IN THE MATTER of Intensification Planning Instrument Proposed
Plan Change 78: Intensification (**PC78**) to the
Auckland Unitary Plan Operative in Part (**AUP**)

JOINT WITNESS STATEMENT IN RELATION TO:

Hearing Topic 020I Precincts I214 Wynyard Precinct

Expert conferencing held on	Tuesday 4 July 2023
Venue	Simpson Grierson office
Independent facilitator	Marlene Oliver
Secretariat officer	Sam Otter

EKE PANUKU PROPOSED HEIGHTS - WYNYARD POINT

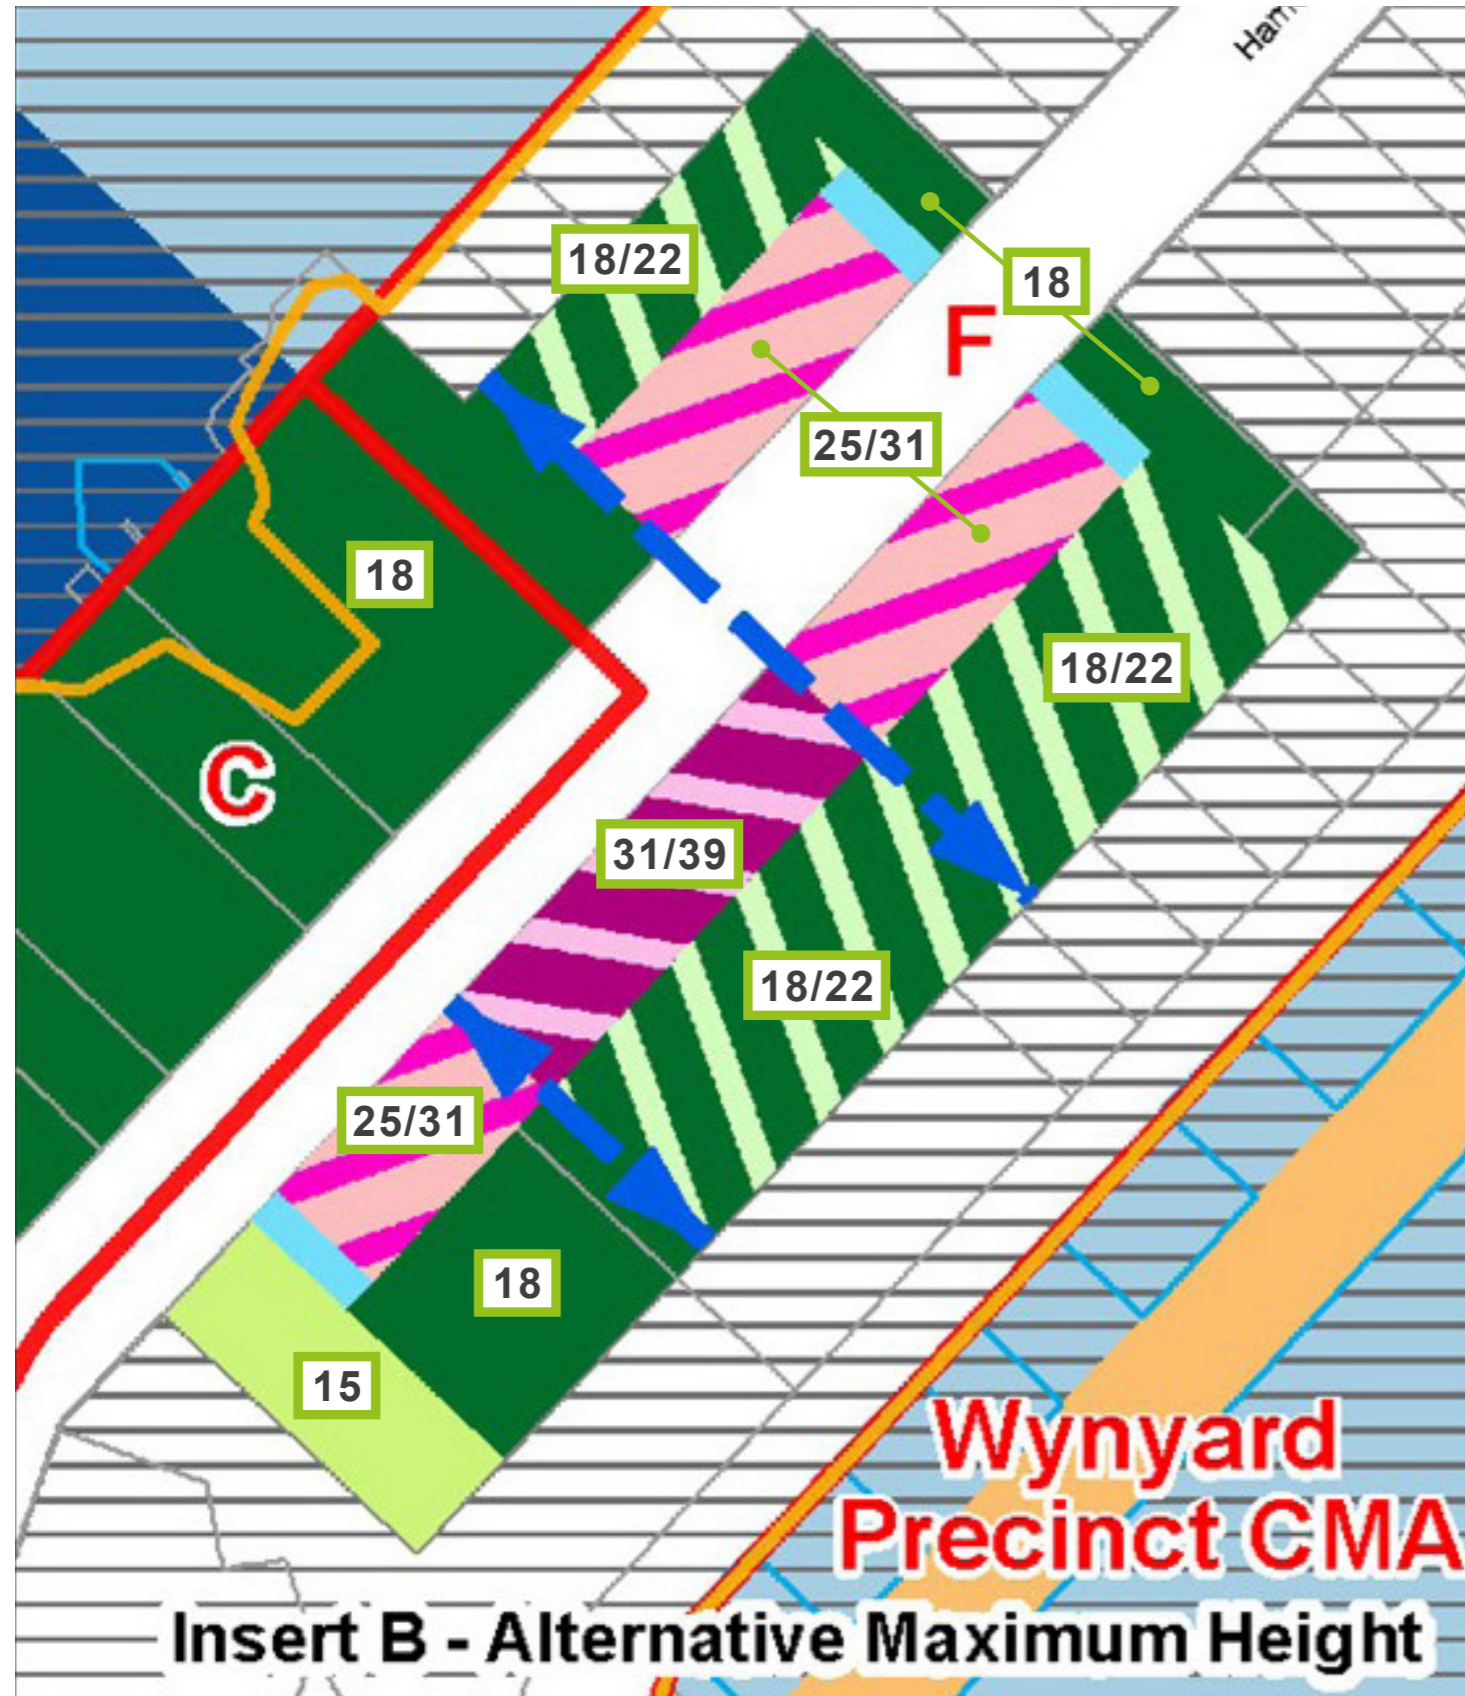
Eke Panuku Proposed Height Wynyard Point – refer to attachment 1

Auckland Council experts agree with the Eke Panuku proposal but they reserve their position on the 39m height until P Kensington (landscape) has reviewed the proposal.

All other experts agree with the Eke Panuku proposal.

VHHL Proposed Optimum Intensity and Heights

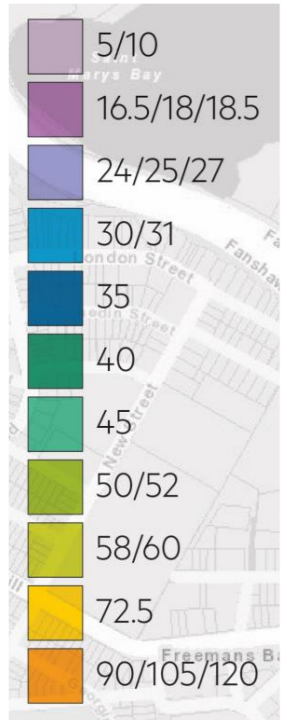
Balance of the Area – refer to attachment 2

Experts for Auckland Council do not support additional height on the Fanshawe Street edge (subject to shading assessments) or along the coastal edges (other than the two sites specified on the map – west end of Jellicoe St, and Swashbuckler's site). They support additional height on some of the marker building sites, as specified on the map. They reserve their opinion on heights across the rest of the precinct.

Experts for Orams support all of VHHL's proposed heights.

The expert for Northbrook Wynyard Limited is of the position is that while some additional height could be supported along the Jellicoe Street axis (as specified above), the changes proposed in the submissions need to form part of a full and comprehensive plan change for the entire Wynyard Precinct to be developed and publicly notified for submissions in order to enable a proper assessment of the precinct description,
